SERVICE BULLETIN

APPLICABILITY: 2013MY BRZ

NUMBER: 06-44-12

SUBJECT: Diagnosis of DTC C1249
Brake Light Switch Malfunction

- Illustration shows the brake light switch and “Gap A” dimension which is explained below.

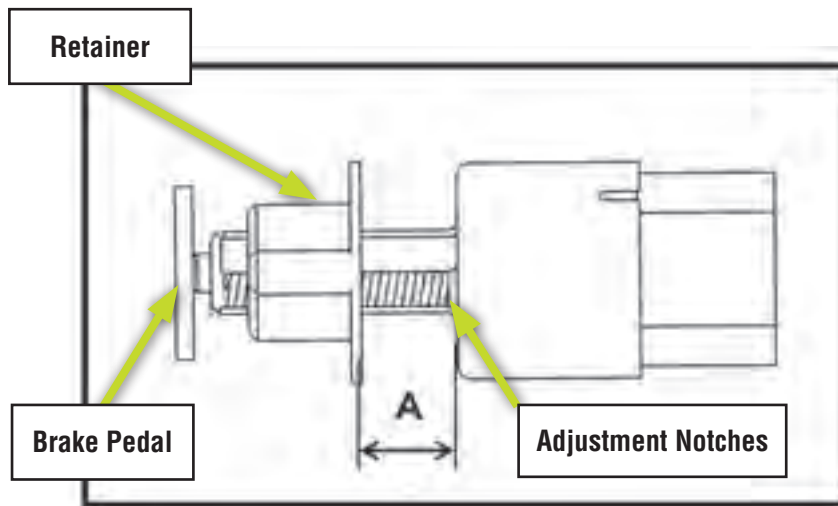
Other possible causes are a faulty or improperly adjusted brake light switch.

- If the pressure measured is exceeds .3MPa (43.5psi) as indicated on the SSMIII, increase the “Gap A” dimension by 1 mm. Before adjusting the brake light switch, add a mark to reference it to the retainer as shown in the photos on page 3. This will help make the adjustment process easier. **CAREFULLY** rotate the brake light switch **SLOWLY**, counter-clockwise approximately 1/4 turn until you feel it begin to release from the retainer. Before it releases completely, move it one “notch” outward toward the steering wheel. Turn it back to the right (clockwise) until you feel it snap back into the “locked” position. You will need to develop a “feel” for the adjustment notches along with how the brake light switch releases and locks back into place. This may involve some trial and error. One notch is equivalent to 1mm of adjustment. If the brake light switch releases completely, insert it back into the retainer until your reference mark is in the original position then try again.

- Once you have increased “Gap A” 1mm as shown in the reference photos on page 3, repeat the pressure measurement.
- If the brake pressure is still out of the specified range and C1249 resets, continue diagnosis following the procedures found in the applicable Service Manual.

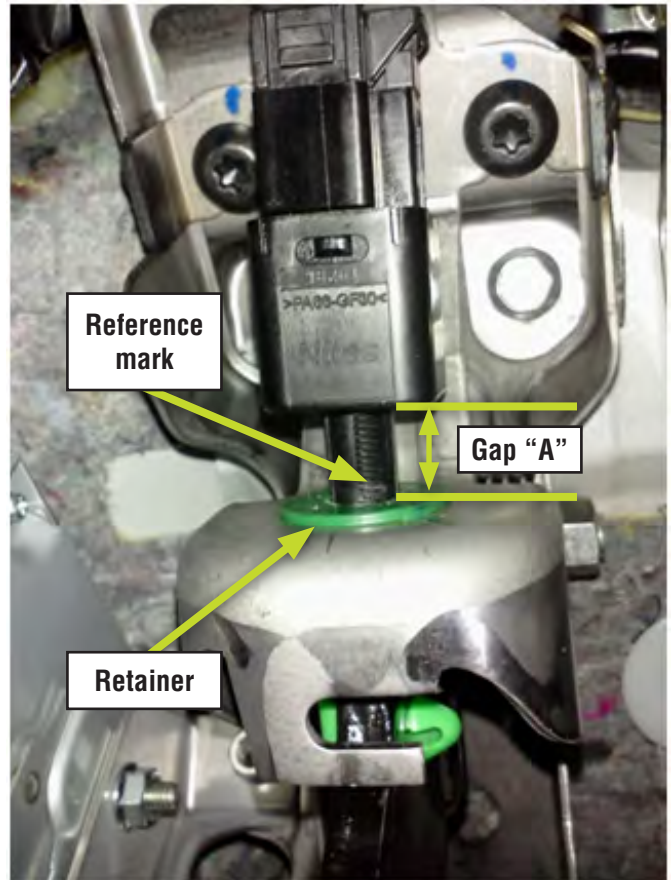
- Connect the Select Monitor (SSMIII). While monitoring the Current Data Display, check and record the master cylinder pressures when:
 - 1) There is no brake pedal pressure being applied.
 - 2) The brake light switch status changes from “off” to “on” while pressing on the brake pedal.

When the brake light switch status turns from “off” to “on”, master cylinder pressure should be between **0.08 to 0.27 MPa (11.6 to 39.2 psi)**.
